Bayside City Council

Submission to Suburban Rail Loop Draft Precinct Key Directions for Cheltenham SRL East

August 2024

Figure 4: Bayside City Council officers' preferred development scenario

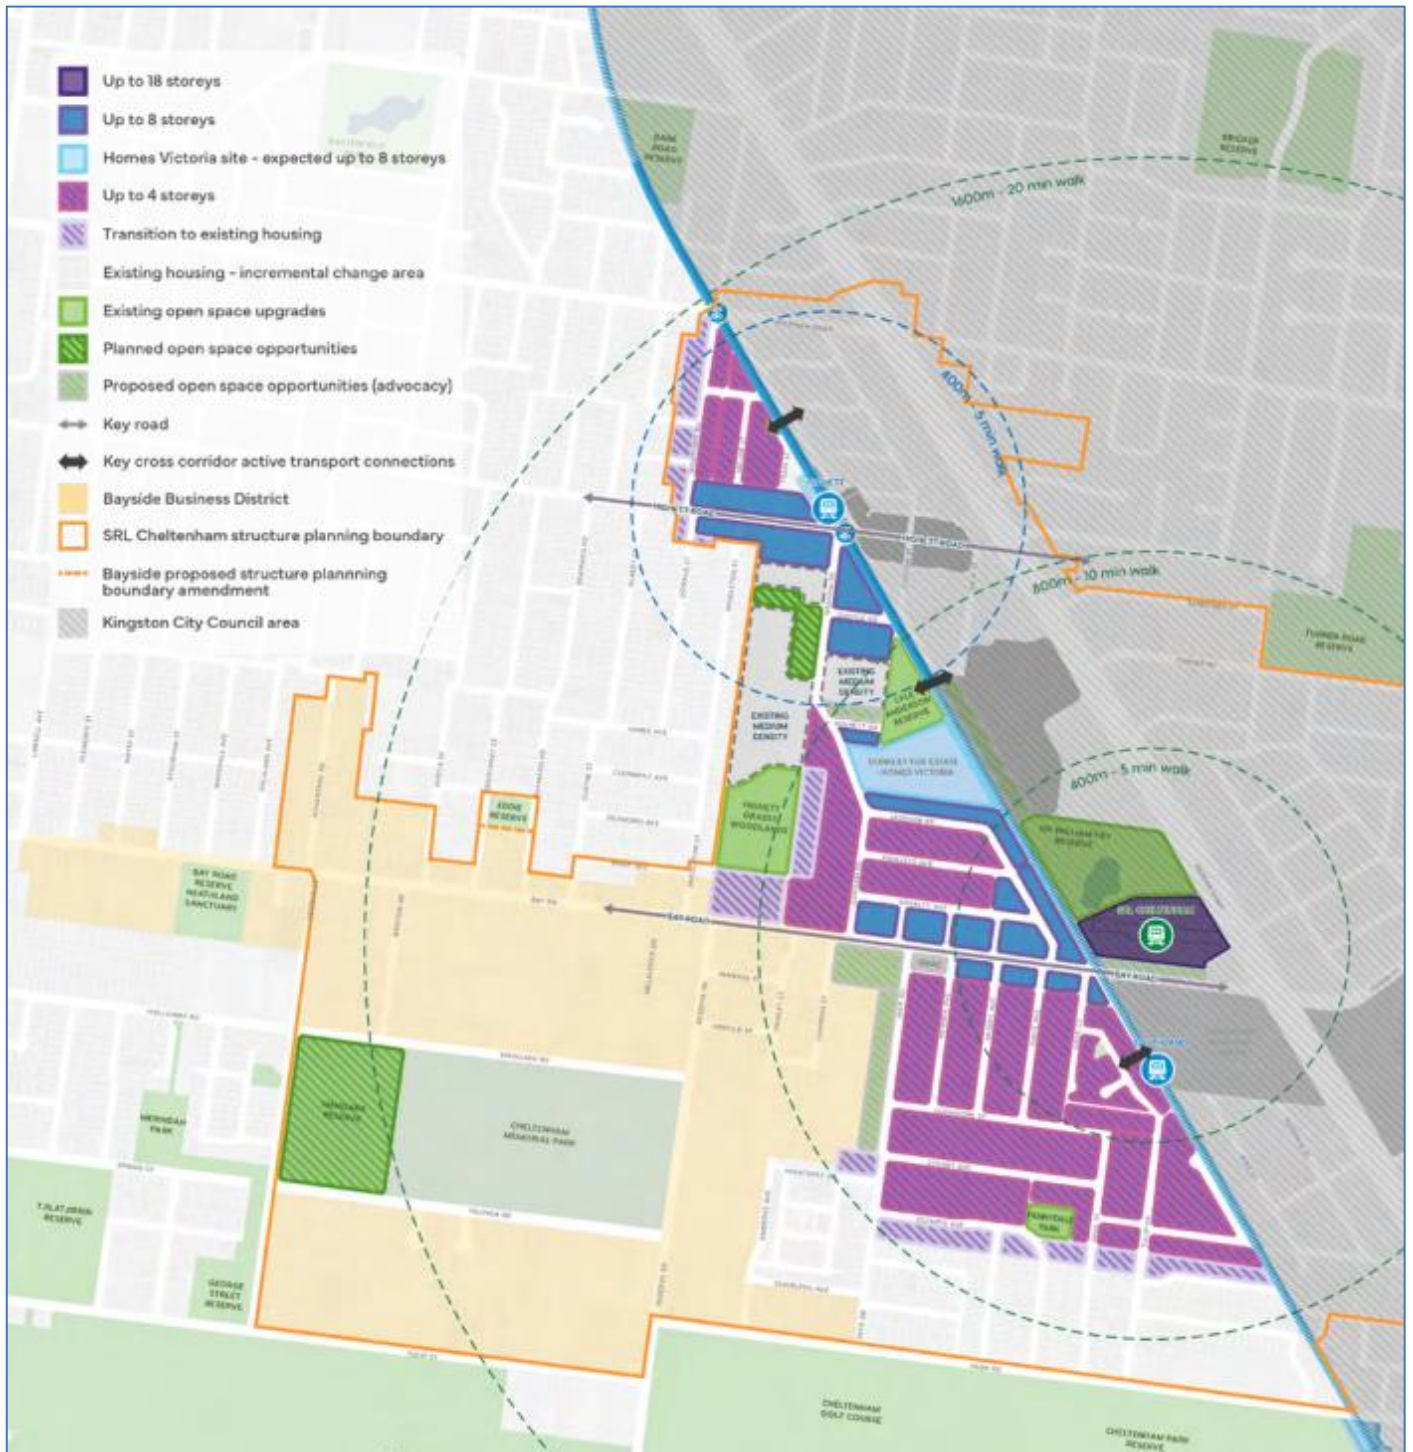
In the absence of any detailed information from SRL or strategic justification for the need for such increased building heights, Council has created its own Housing Density map (Figure 4) as included below and separately in Council's Position Paper Summary (Appendix 1). This map identifies areas where Council believes increases in density is most suitable within the precinct. A key consideration of Council in the preparation of the proposed density map was how to increase the density of the precinct in an appropriate manner, without compromising the amenity and character of existing residential areas.

Council's preferred scenario (Figure 4 and 5 above) is considered to align well with the expectations of the community to minimise change where possible and appropriate:

- The highest level of change would be accommodated along the rail corridor north and immediately south of Bay Road, and around Highett Station.
- It includes transitional change areas of up to 4 storeys, and transition to areas of predominantly single storey dwellings. Lot consolidation would need to be encouraged and/or incentivised to achieve good density outcomes in these transitional areas.
- By concentrating the significant redevelopment potential along Bay Road, the rail corridor, and around Highett Station, many of the existing residential neighbourhoods in Highett and Pennydale could develop at a slower rate.
- This scenario assumes that the existing public housing at the Fox Dunkley Estate could be redeveloped up to 8 storeys.

- The scenario assumes some new areas of open space to offset the increase in population, subject to future needs analysis and developer contributions..
- There is no support to override the approved Development Plan for the former CSIRO Development. The SRL should not seek to increase building heights or density in this area any further than what has already been approved by Council.

Figure 7: Main Cyclist corridors on Tulip and Park Street

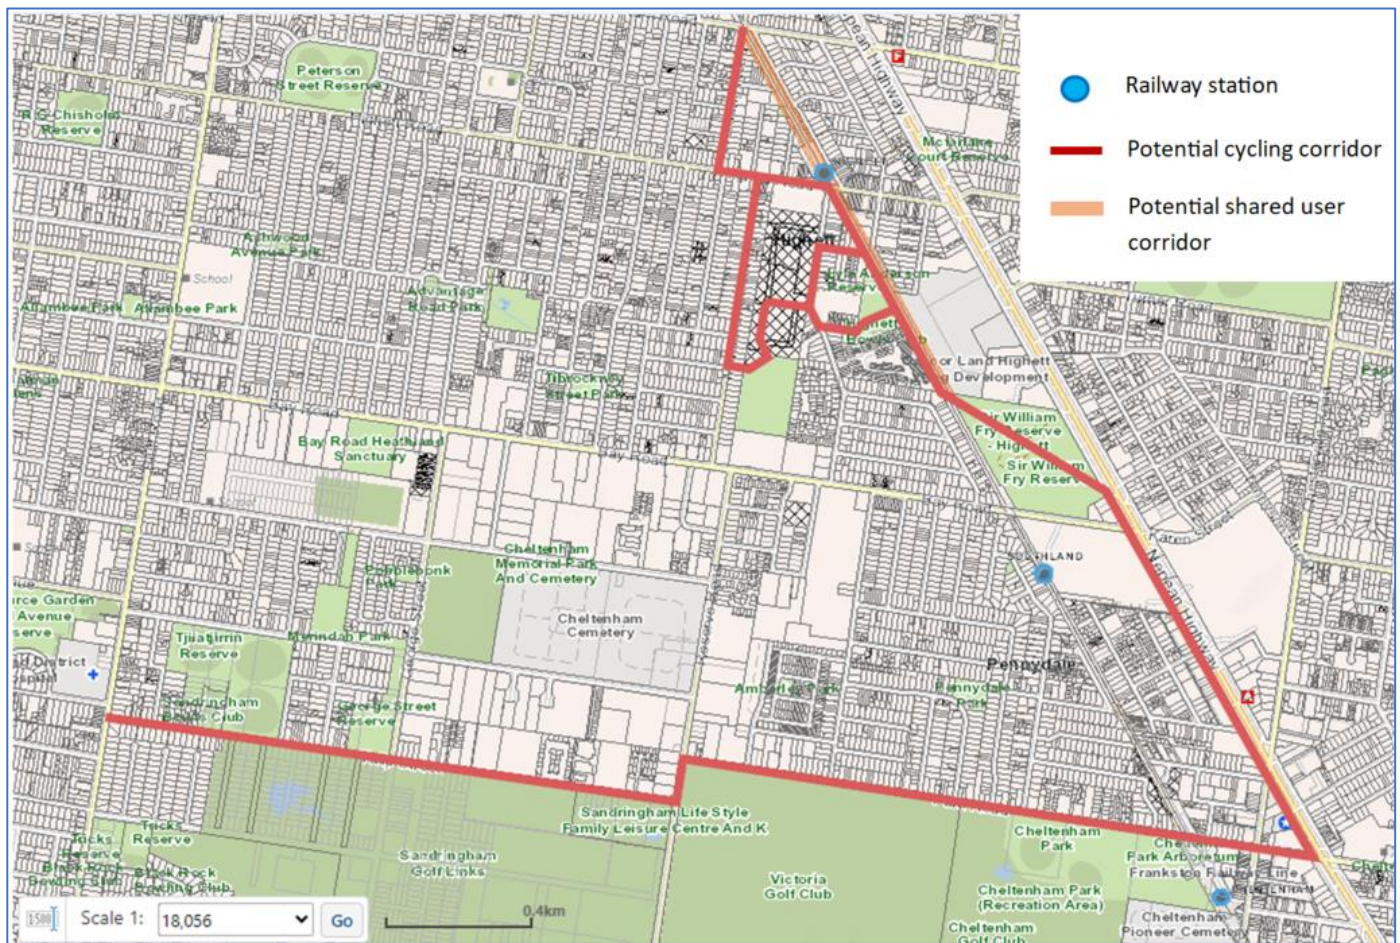
Council strongly opposes the narrowing of Bay Road to single lane each to allow for a cycle path – which is part of SRLA's current Reference Design for the road. On the contrary, Council suggests that Bay Road:

1. Be expanded by procurement of private land to expand the two lane arrangement; and/or
2. Accommodate main cycling corridors on alternative streets within the precinct (Wickham, Tulip and Park Road) to all lead towards Highett, Southland and SRL stations as pictured below.

Figure 8: Bayside City Council Preferred Cross connection corridors and Active transport corridors

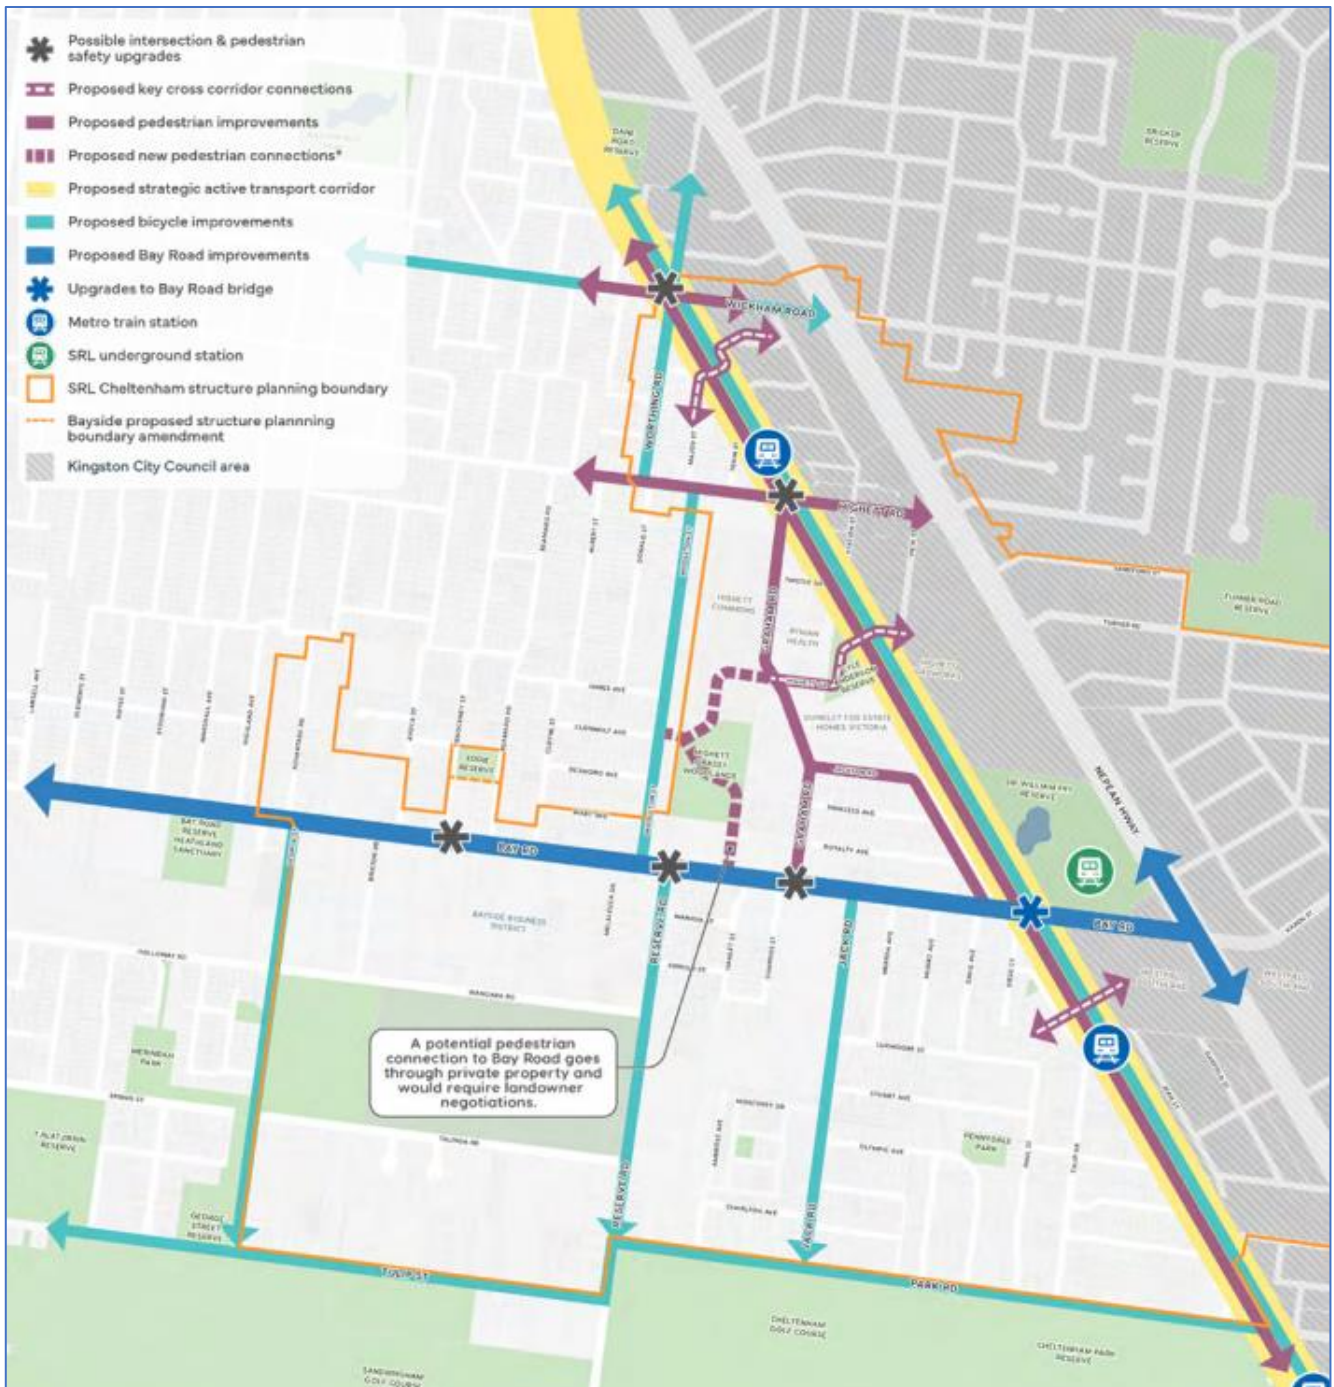
This north-south pedestrian spine could then be complimented by at-grade, cross-corridor connections under the elevated rail between Lyle Anderson Reserve and Highett Gasworks and other locations (map 7).

Figure 8 identifies where key cross corridor connections pedestrian improvements and cycling improvements could occur.

Figure 9: Bayside City Council Preferred movement map for Cheltenham Precinct Core

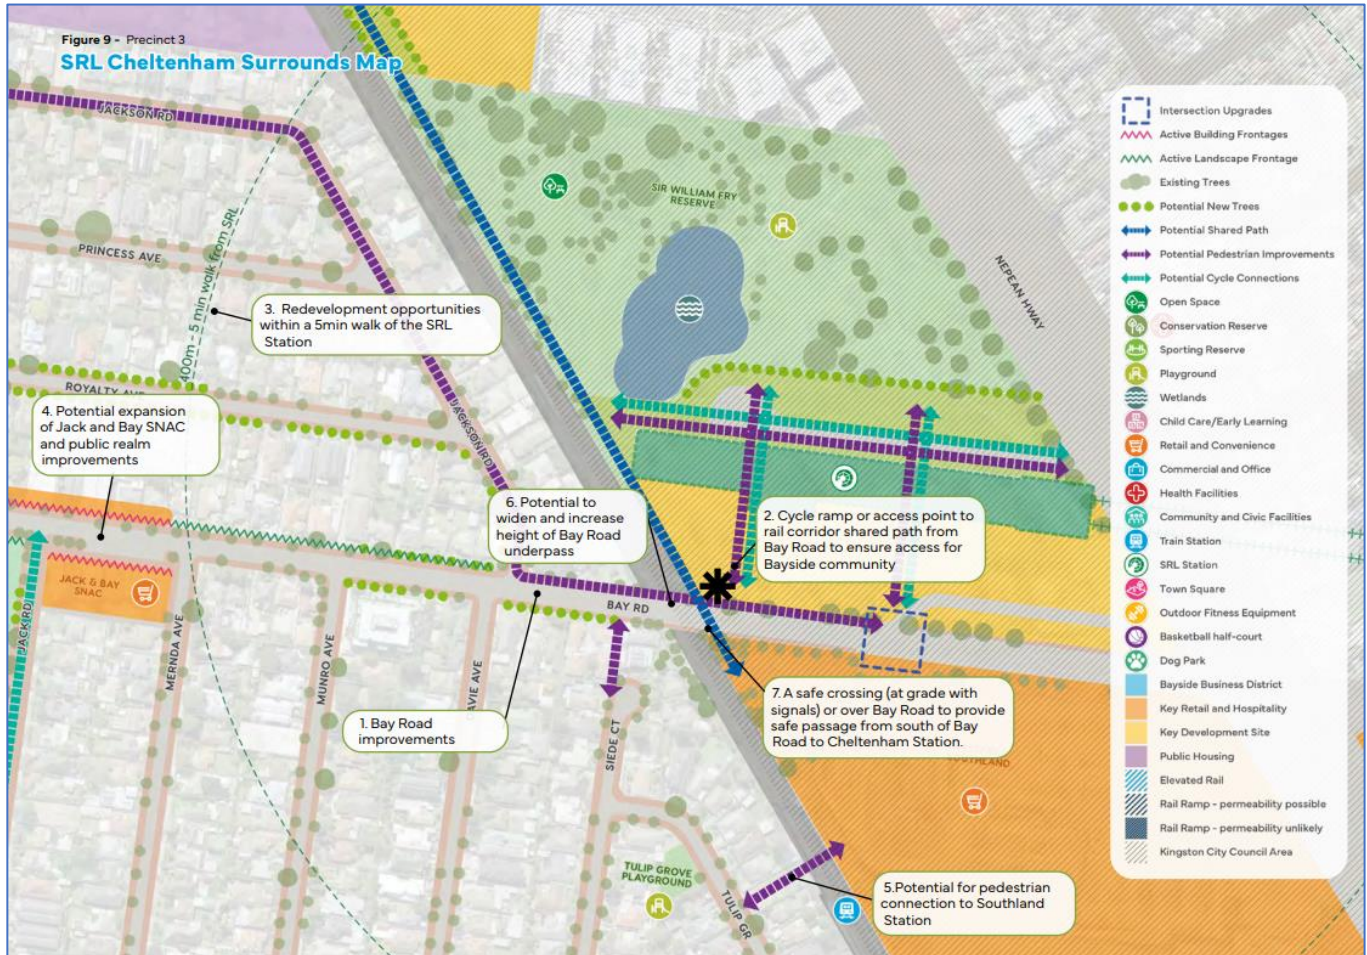
Figure 9 identifies the following pedestrian safety and cycling improvements:

- Widen and increase height of the Bay Road underpass
- Potential pedestrian connection to Southland station to provide greater accessibility to the train stations without the need to walk around and on Bay Road
- Undergrounding of powerlines on Bay Road but also throughout the entire precinct area to optimise ability to green both the private and public realm
- Syncing of traffic lights along Bay Road (and other main roads) to ensure traffic flow can be directed appropriate during peak hours and all other times
- Multiple pedestrian access points to the Station should be a priority to ensure seamless connection for Bayside residents north, west and south of the Station.

Figure 10: Bayside City Council Preferred movement map for BBD and Bay Road

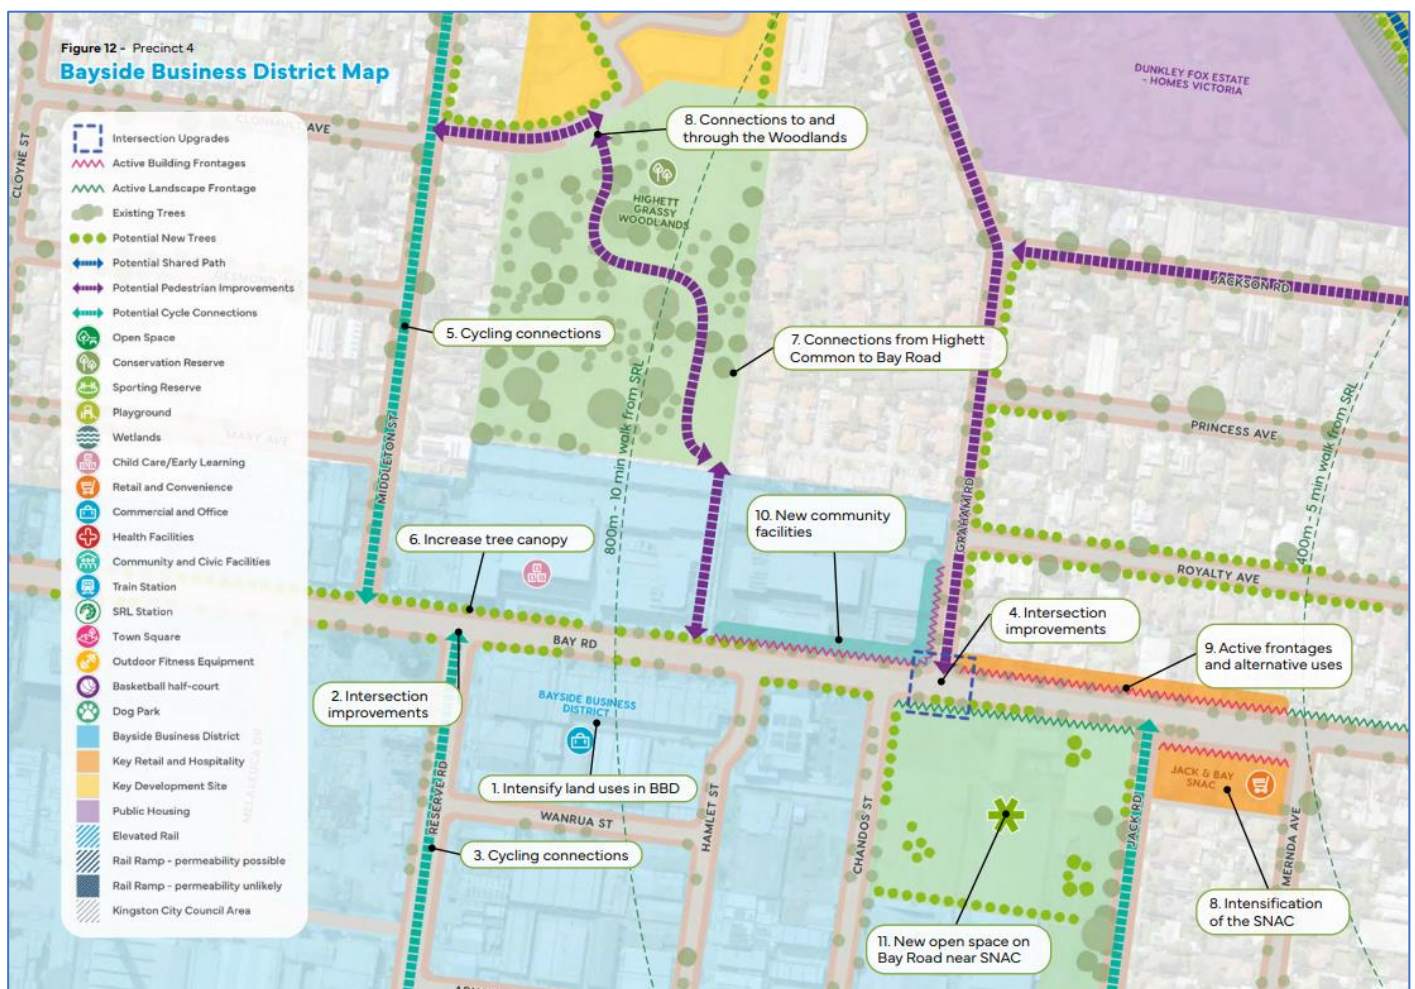
Figure 10 identifies the following pedestrian safety and cycling improvements:

- Pedestrian safety improvements at the existing Reserve Road/Bay Road intersection including pedestrian crossings and signals on all legs of the intersection.
- Undergrounding of powerlines
- Signalisation at the Graham Road/Bay Road intersection including pedestrian crossings and signalisation (in motion)
- Pedestrian/cycling improvements to Bayside Business District including safe crossings, bicycle lanes where appropriate, bike infrastructure such as bike racks.
- Inclusion of a pedestrian crossing on Bay Road in the vicinity of the Aldi supermarket
- Provide for improved pedestrian (and potentially cycling) connections into Highett Grassy Woodland and through to Bay Road.

Figure 12: Bayside City Council Preferred movement map for Highett Residential Core

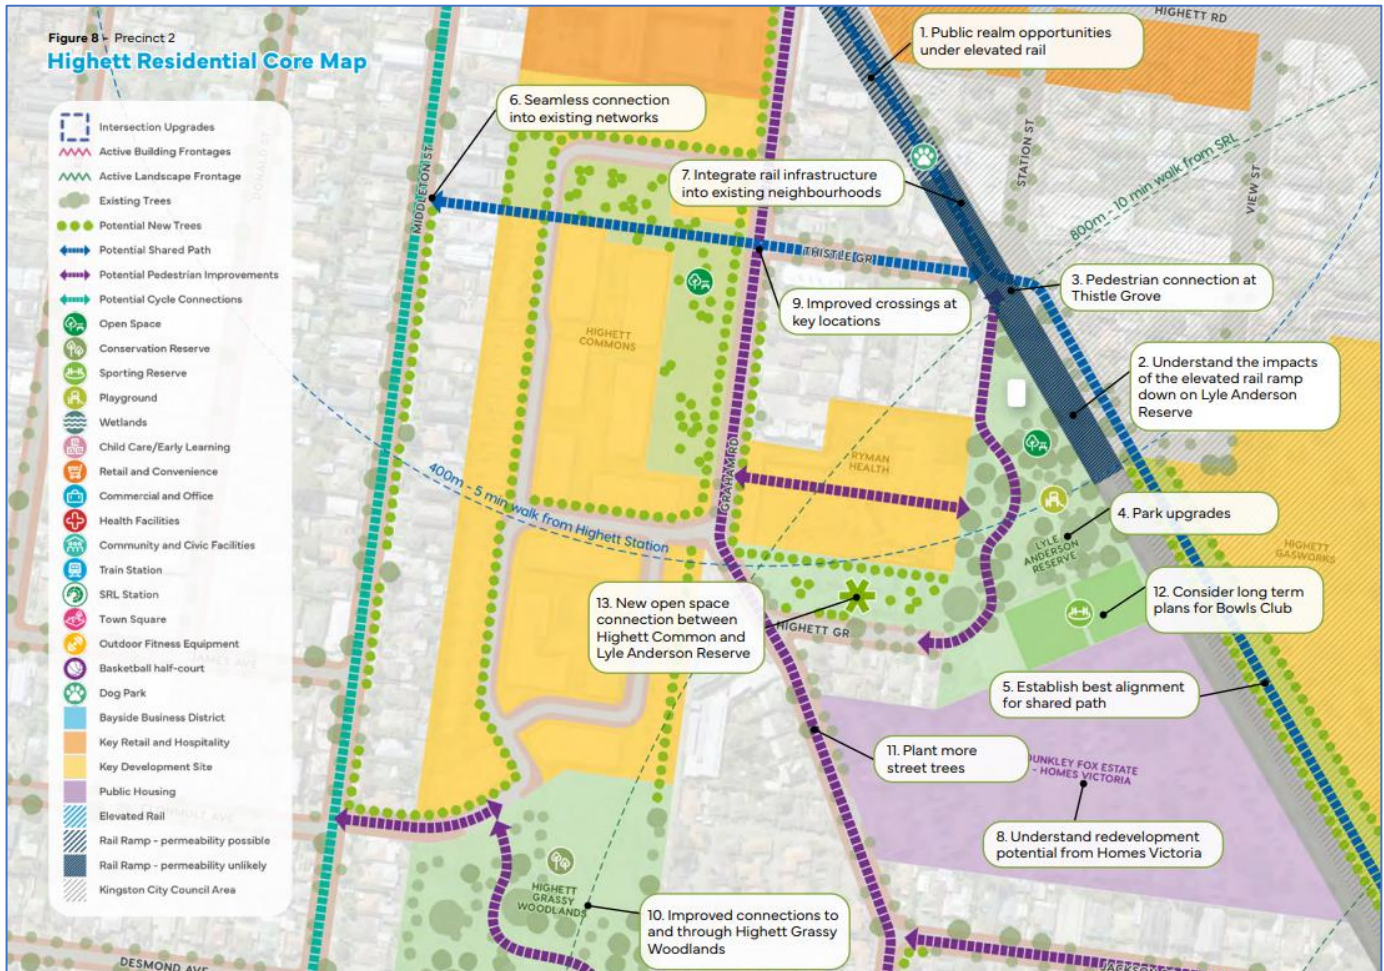
Figure 12 identifies the following pedestrian safety and cycling improvements:

- Create pedestrian-focused environment in Highett Village by building kerb outstands and narrowing crossing distances and by visually demarcating crossings. There is great volume of interchanging passengers at this location, with poor provision of bus facilities. Council suggests providing new bus shelters and seating for east/west routes incorporated into the urban realm.
- Improved pedestrian connection along Graham Road and into Highett Grove and through Lyle Anderson
